Service Advisory CC-355

LAWN TRACTOR AND SERIES 2000

Model: 2185

Subject: MECHANICAL FUEL PUMP

Figure 1.

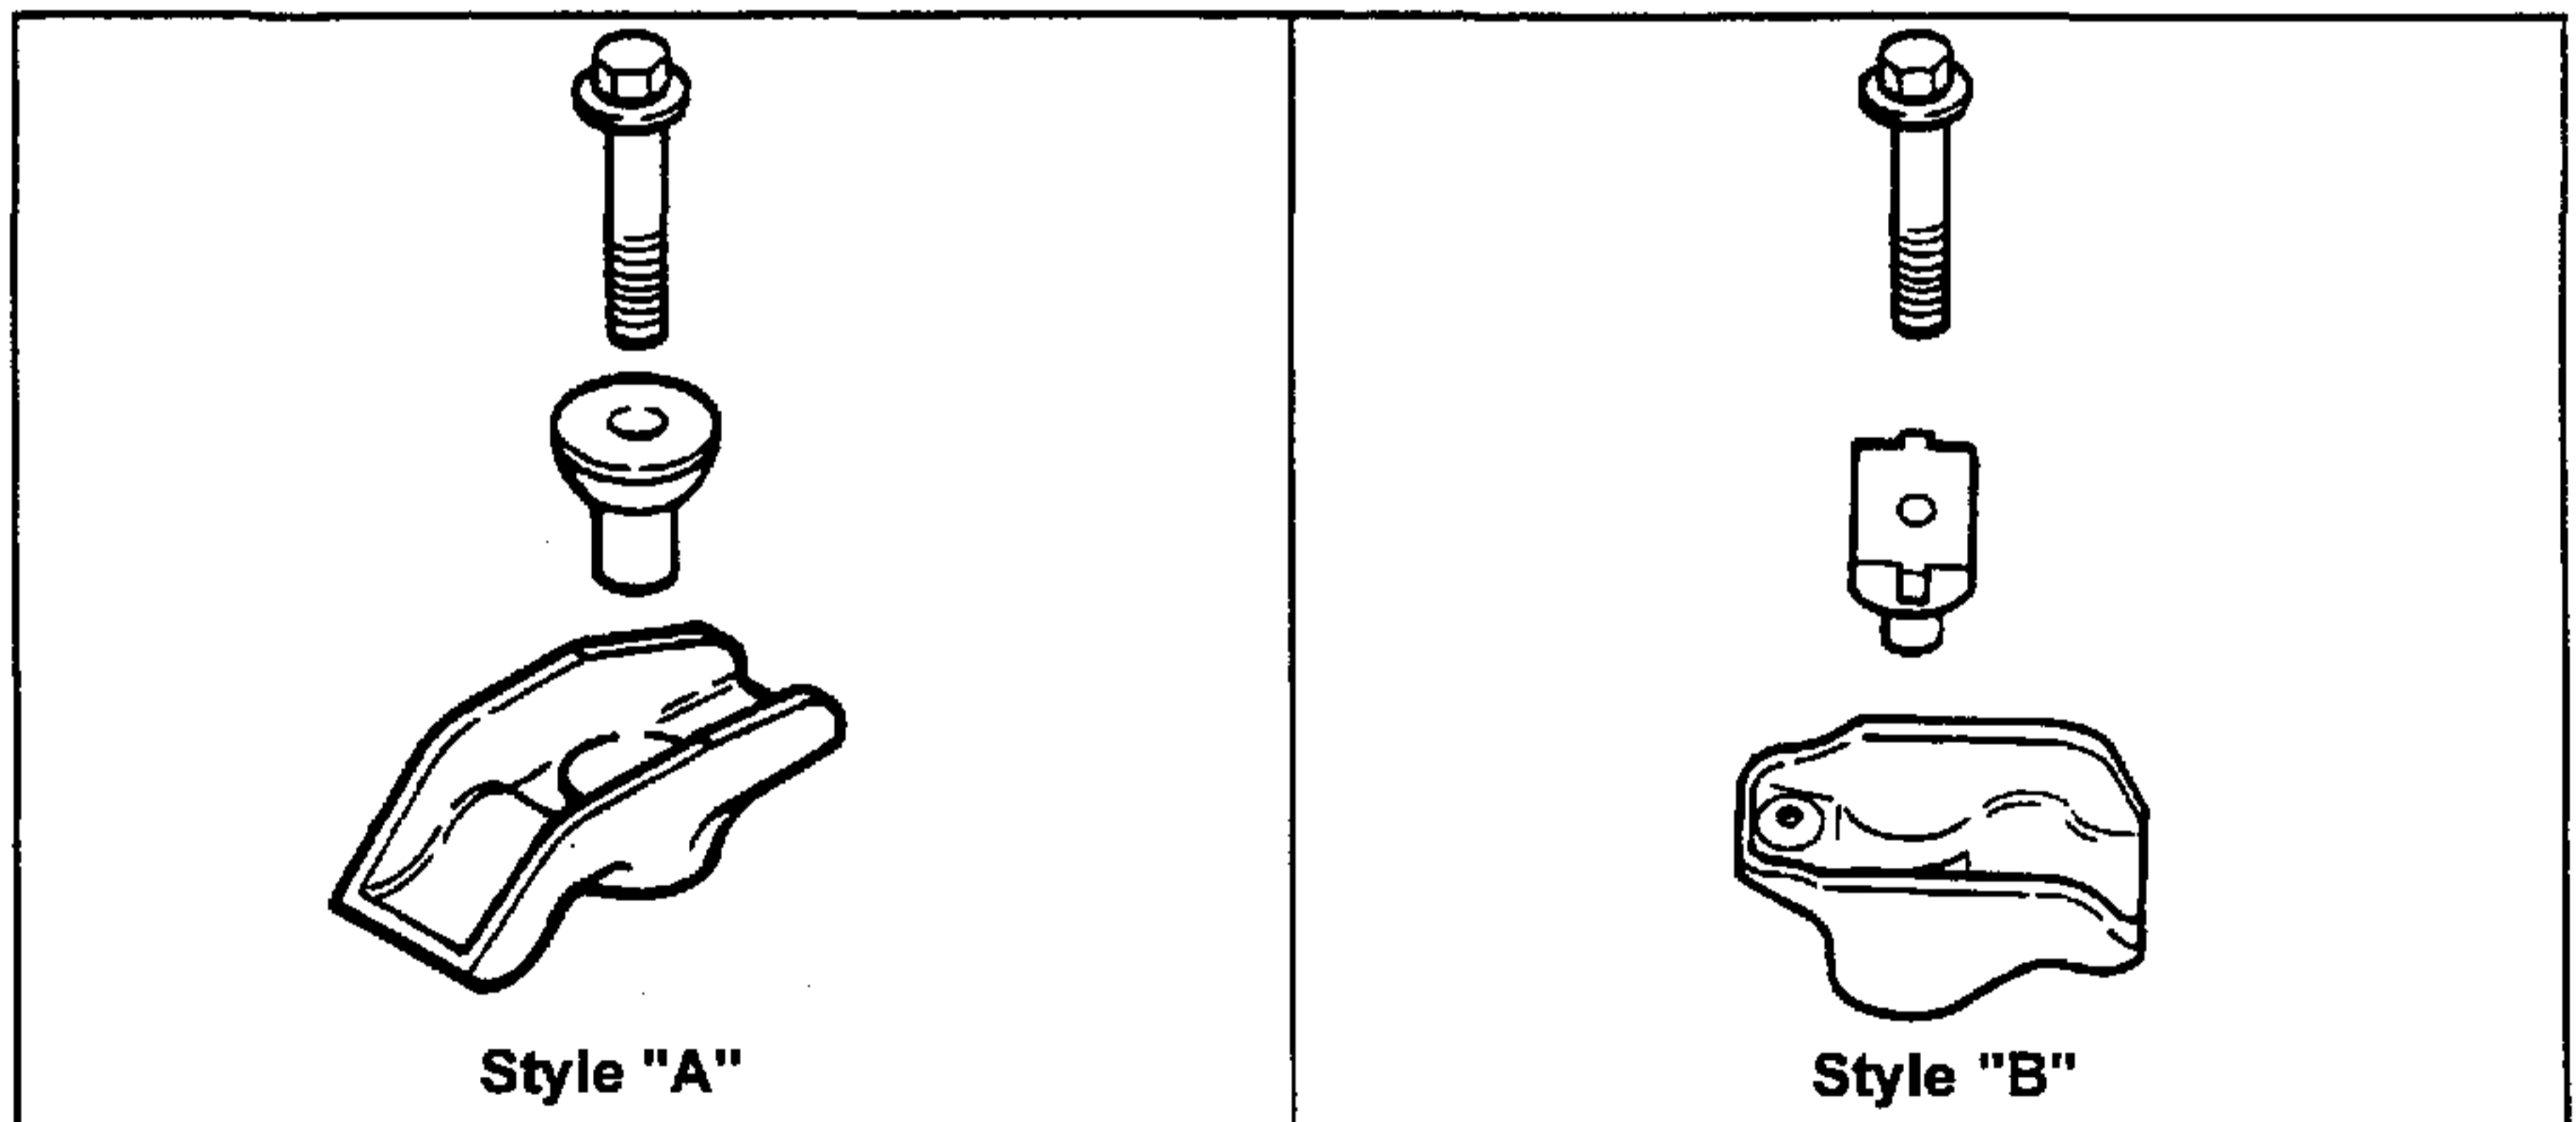
A fuel pump retrofit kit (part number KH-24-559-02) has been developed for converting engines with the original pulse pump, but the latest Style "B" (see Figure 1) rocker arms are required. Engines above serial number 2520800007, or those that have KH-24-755-66 valve train kit installed (refer to Service Bulletin CC-341), will have the Style "B" rocker arms and can accept the new kit. Engines that have Style "A" rocker arms (see Figure 1) must be changed to the Style "B" by installing KH-24-755-66 kit before the mechanical pump kit can be installed.
